Reg. Ref. 4674/22: Proposed  
Development at 1-4 City Quay,  
5 City Quay and 23-25 Moss  
Street, Dublin

Report on Townscape and Visual  
Impact for 1st Party Appeal

Prepared by Model Works Ltd for  
Ventaway Ltd

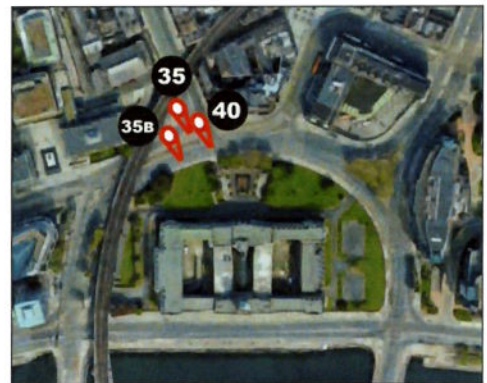
The following photographs and photomontages show (a) that the existing and permitted buildings in the environs of the Custom House can be seen protruding above its roofline from most directions of view, and (b) that the proposed development would have a similar visual presence.

Depending on the angle and distance of the view, the existing and permitted buildings protrude to various extents above the Custom House roof, and *from particular positions* they may be close to or directly behind the cupola (as illustrated by the photomontage below showing the AquaVetro tower behind the cupola).

It should be noted that in the case of the proposed development, the particular vantage point at which the tower would rise behind the cupola (Viewpoint 35b – shown above) is not an important viewing position or approach route to the Custom House.

This is a position on Beresford Place, off the axis of Gardiner Street. The view would be only fleetingly experienced while travelling east-west along the street. Given the similar effects of various existing and permitted buildings, the significance of this visual impact is classified 'moderate neutral' in the LVIA.

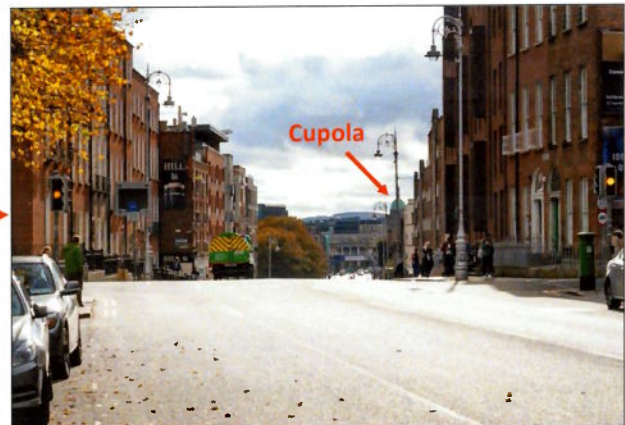
The DCC Planner's Report states: "... the scheme would, by reason of visual intrusion, have a significant and detrimental visual impact on a number of important views and vistas in the city, as referenced in the Dublin City Development Plan Key Views & Prospects (Fig.4), including those views from... Mountjoy Square, Gardiner St Lower...

In particular, the views from Gardiner St (View No. 35, 38 & 39) and Mountjoy Square (View 37) illustrate the stark reality a proposed building of such scale and mass will have on the Dublin skyline and the corresponding detrimental visual impacts on the integrity of the historic Custom House building."

- The proposed development would have no visual impact on the open space of Mountjoy Square – as shown by the new photomontage prepared for the appeal, included below. As a typical Georgian Square, the space is enclosed by a belt of perimeter trees and tall, terraced houses, which block views towards the site. Additionally, the topography falls steeply down towards the Liffey, so

that the site is well below the elevation of the square. (The building is outlined in red in the view below.)

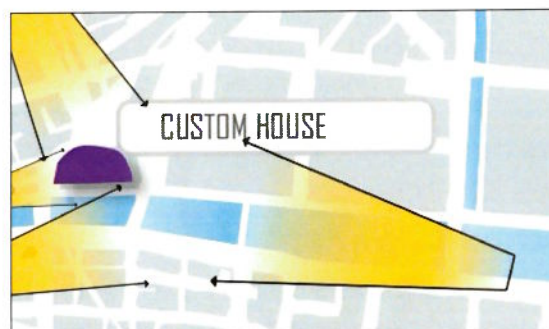
In response to an observation by the OPW, a new photomontage has been prepared to assess the effect on a protected view identified in the DCDP 2016 (and Draft DCDP 2022).

This is the view from the south quays in the vicinity of the Samuel Beckett Bridge, with the Custom House the focus of the view. The photomontage is provided below.

Similar to View 45 (see preceding page), this view shows (a) the considerable separation distance between the proposed tower and the Custom House across the river, which negates any sense of crowding/

overbearance despite the difference in scale between the two elements, and (b) the additional capacity for change resulting from the predominance of modern development. If there is a district in the city that can accommodate contemporary tall buildings – as compact growth policy demands – it is this area.
